Amendments to the Drawings:

Method and System for Assisting in Backups and Restore
 March 31, 1998 / Docket No.: EMC-97-137
 Robert Kevin Perkins, Esq. (Reg. No. 36,634)
 November 20, 2002

FIG. 3

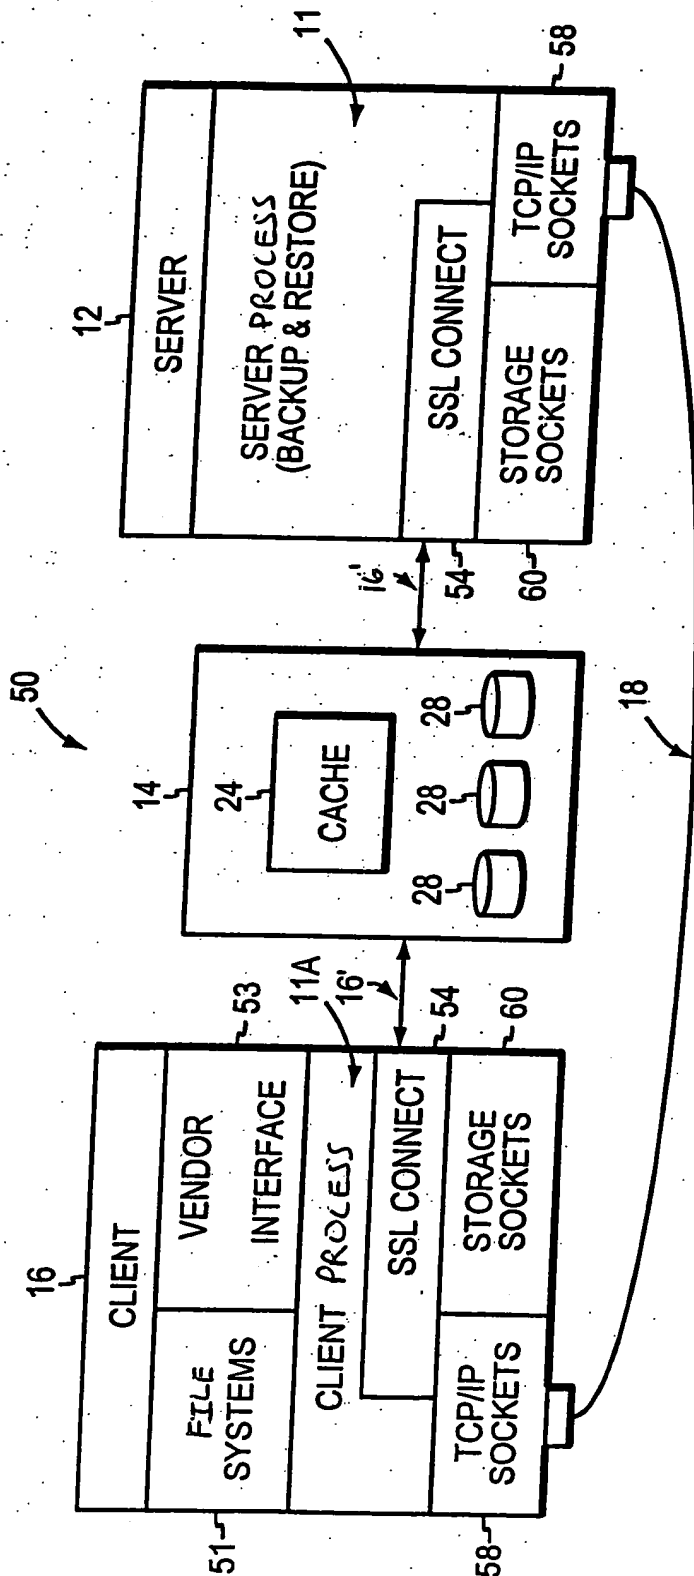
In Fig. 3, “EDM” was deleted from both of boxes 54 to make the figure consistent with the Specification.
